**PLANNING COMMISSION AGENDA**

Tuesday, June 04, 2013  
Breckenridge Council Chambers  
150 Ski Hill Road

## PLANNING COMMISSION MEETING

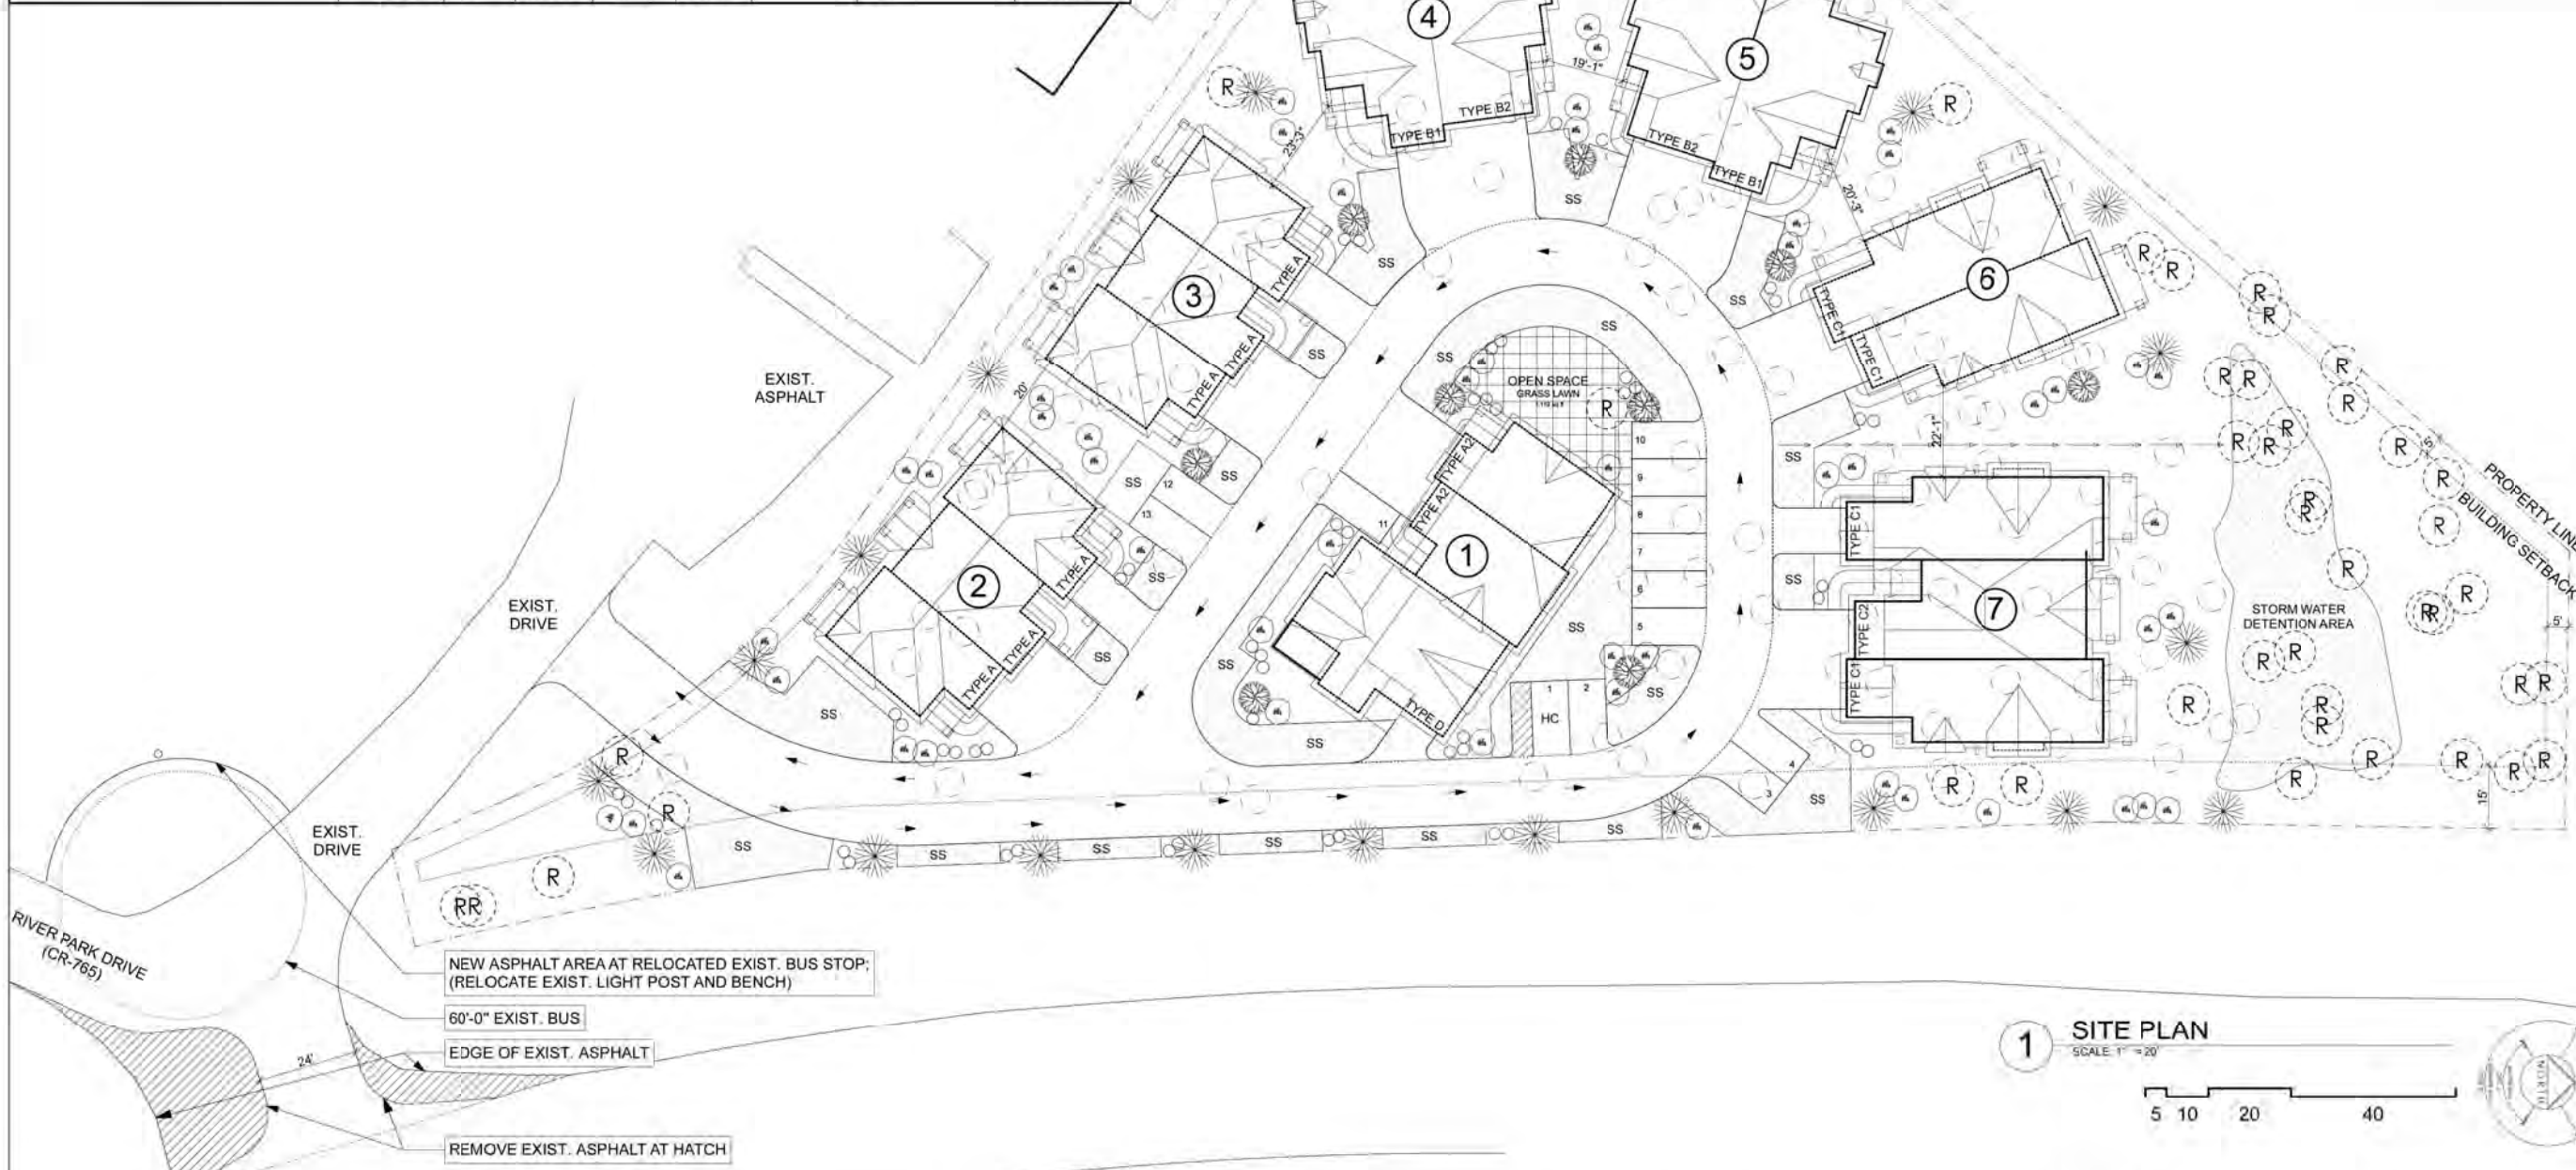
At the last worksession, the Commission reviewed a site plan for the development. Concerns were raised from Staff and the Commission about the Site Buffering and Privacy (Policy 7, Site and Environmental Design) and the efficiency of the snow stacking (Policy 9, Placement of Structures/ Snow Storage), resulting in the following preliminary points assessment for the project.

Responding to these concerns the applicant has returned with a modified site plan showing:

- Landscaping has been added between units adding to the buffering and privacy.
- The snow stacking areas on the outside of the private drive have been increased slightly.

As a result of these modifications, Staff believes the concerns regarding the Site Buffering and Privacy and the efficiency of the snow stacking have been resolved to a point where no negative points are suggested.

- Mr. Mamula: Whenever you get a project with negative points that are all coming from snow stack, buffering or landscaping, there is simply too much product on the site. Unless you can work through these negative points, this will fail. I don't know that I'm necessarily buying your snow storage argument. It is not efficient. Your three points shy of passing, at a first blush. It's just too dense. I would like to know from Council if we have the ability to go less than 7 points for the housing. I don't know that we've ever had the Council put a point total for Planning before. (Mr. Grosshuesch: The Housing Committee did not believe they should get the full 10 points because the project didn't meet the 80/20 rule.) I would feel more comfortable with a point range; if the Council wants to know what we think, it would be nice to have some flexibility. The architecture is all great; better than before, but it just doesn't fit on the site.

LANDSCAPE PLAN

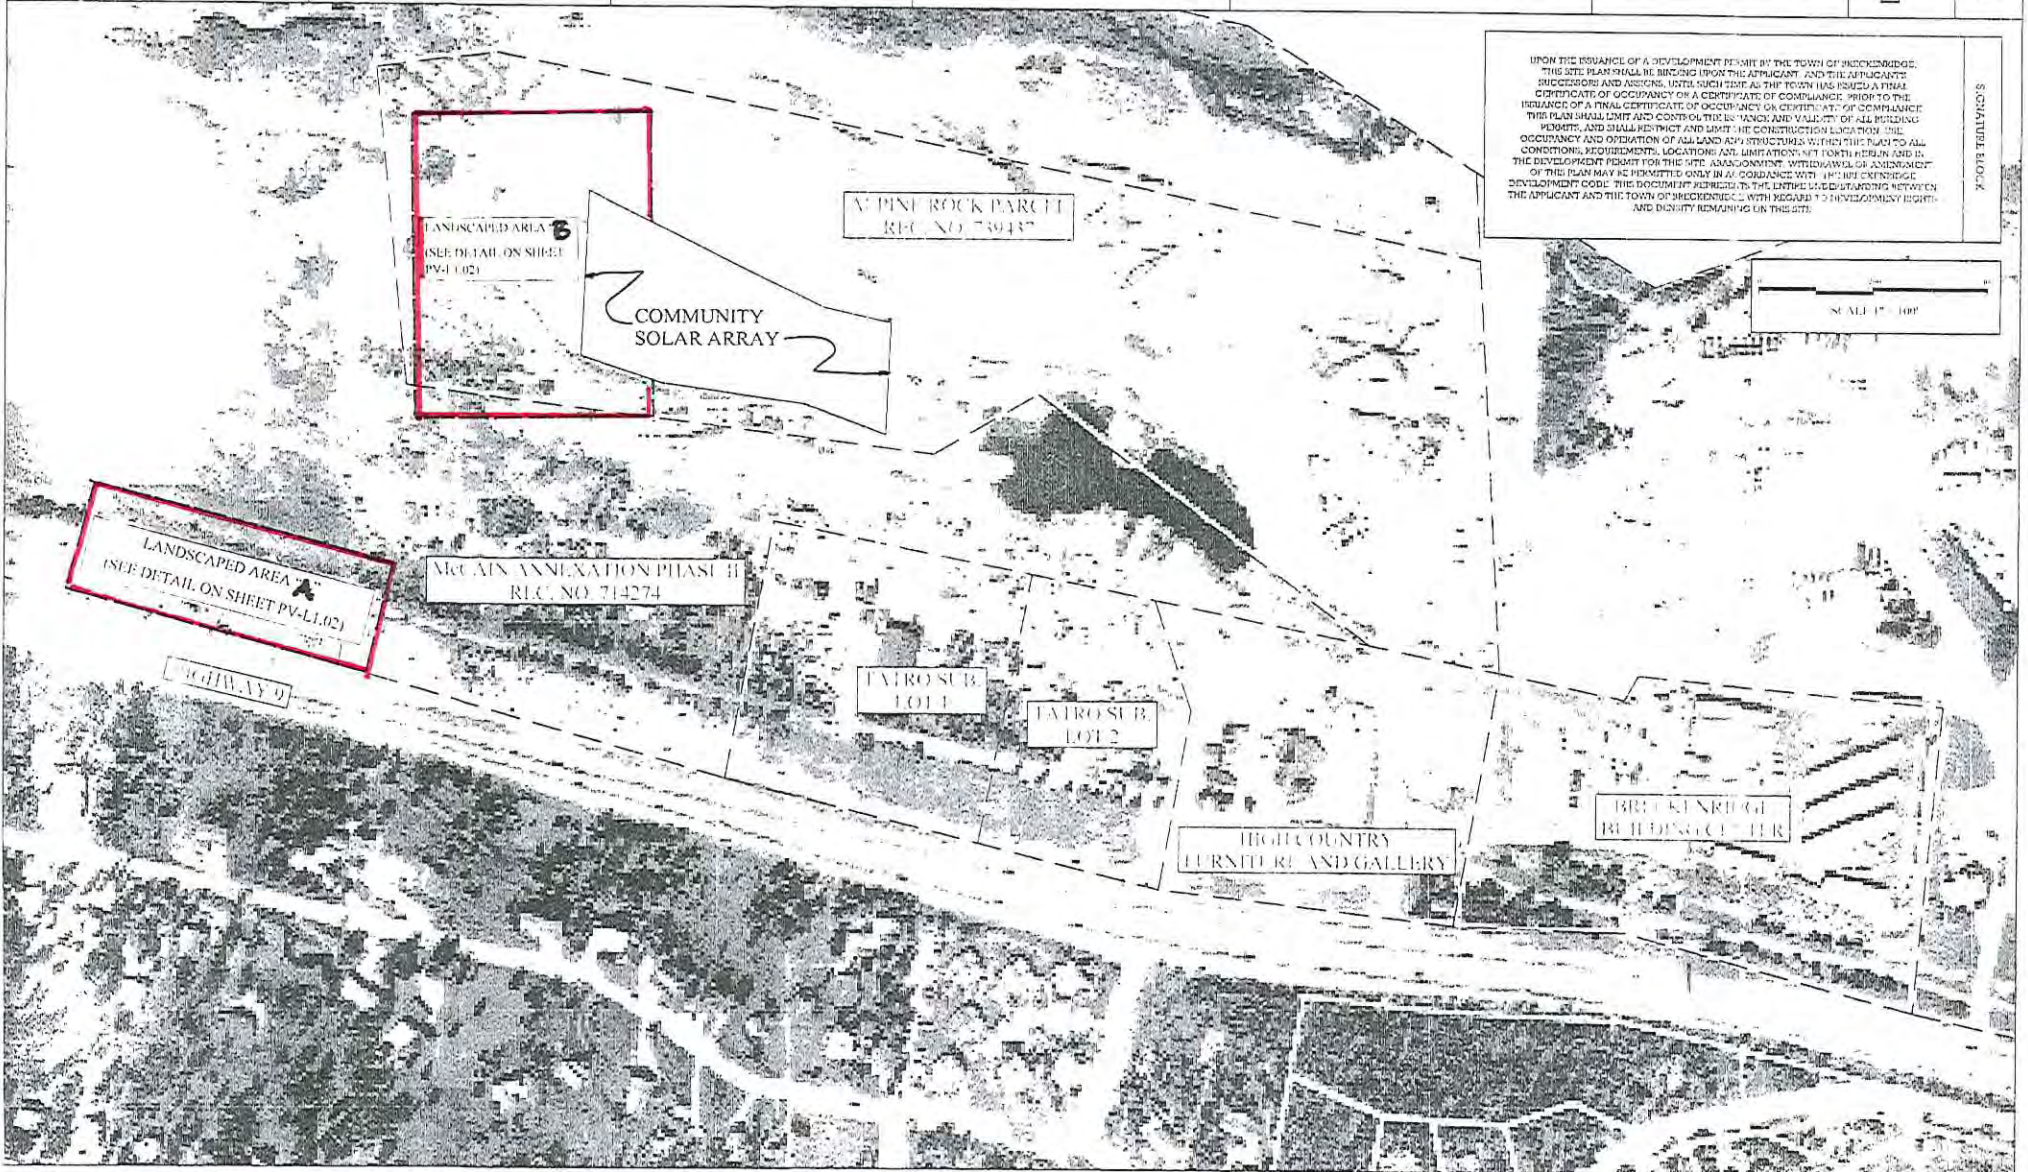
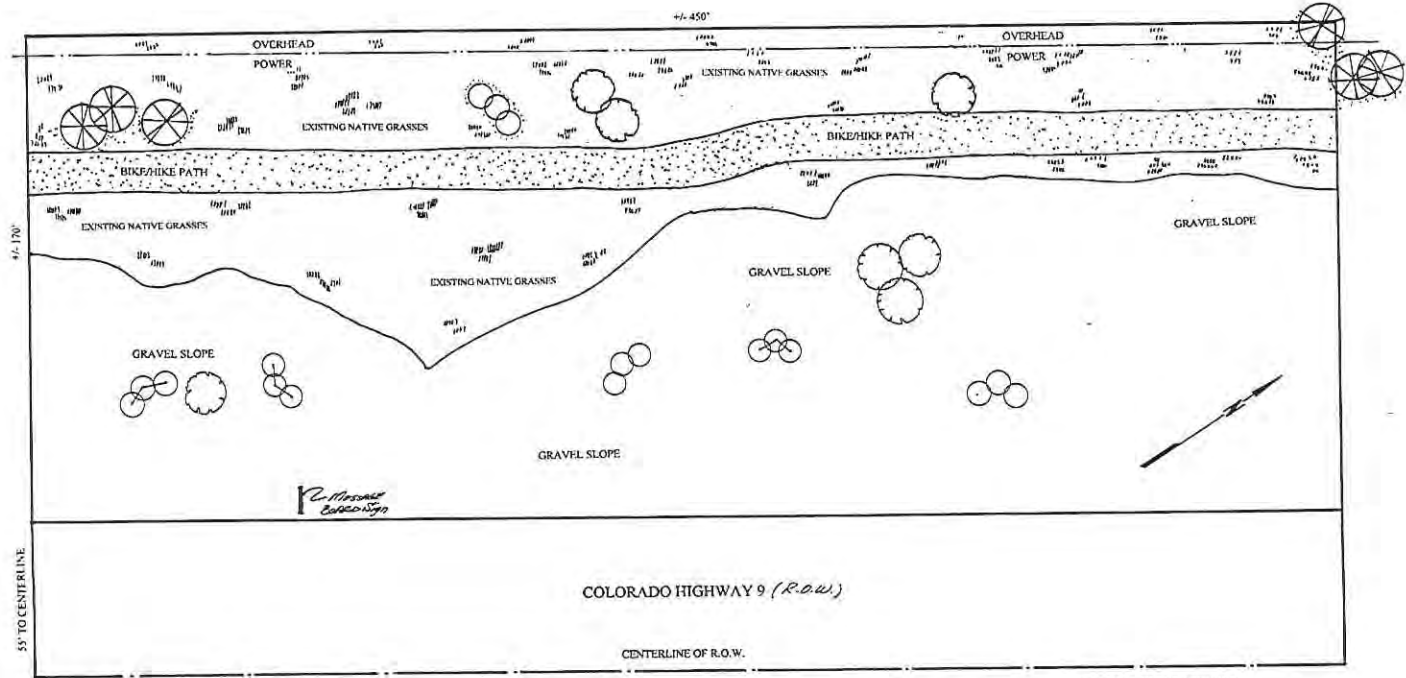
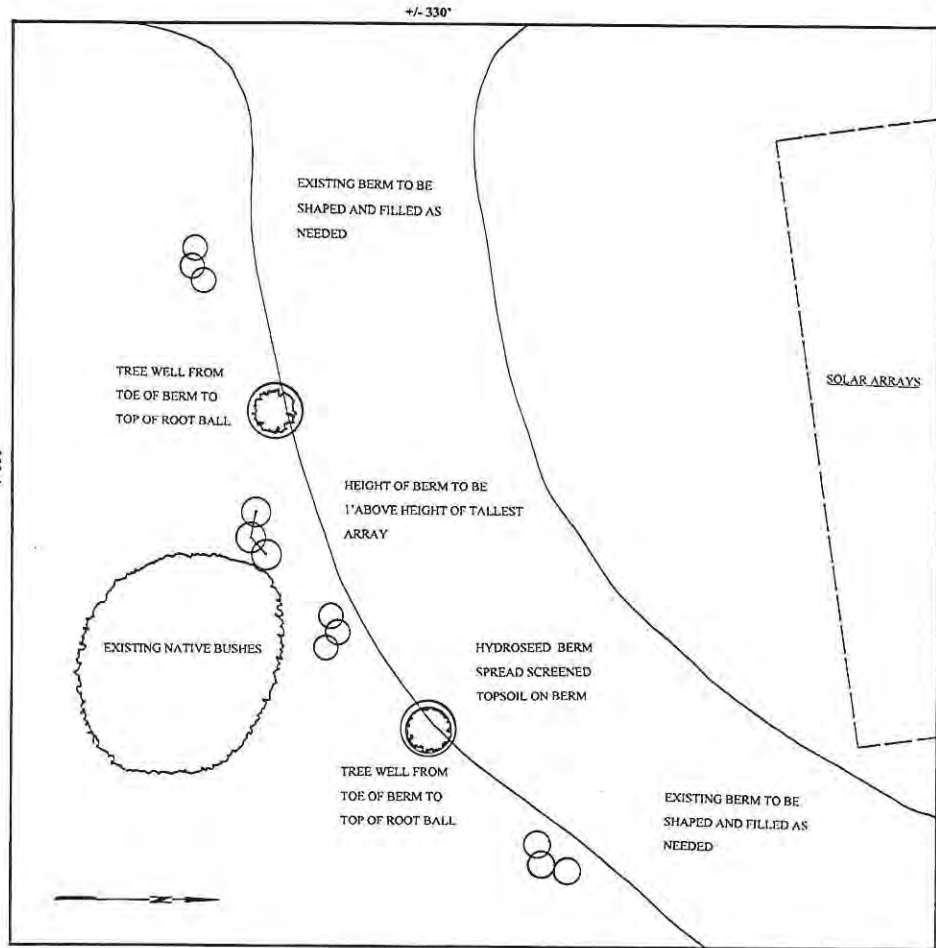
The primary concern from the Planning Commission was additional visual buffering to the site from the Highway 9 and Coyne Valley Road rights-of-ways.

**Landscaping (22/A & 22/R):** The lease area site is void of any existing vegetation. The applicants are planning to introduce plantings to create buffering from view corridors of Highway 9 and Coyne Valley Road right-of-way. To accomplish this approach, staff is supportive of the applicants planting outside of their lease area. A covenant running with the land lease will be required. This is a condition of approval.

Trees are shown in response to field visits regarding site visibility. Exact locations will be determined once the solar panels are installed to ensure strategic screening.
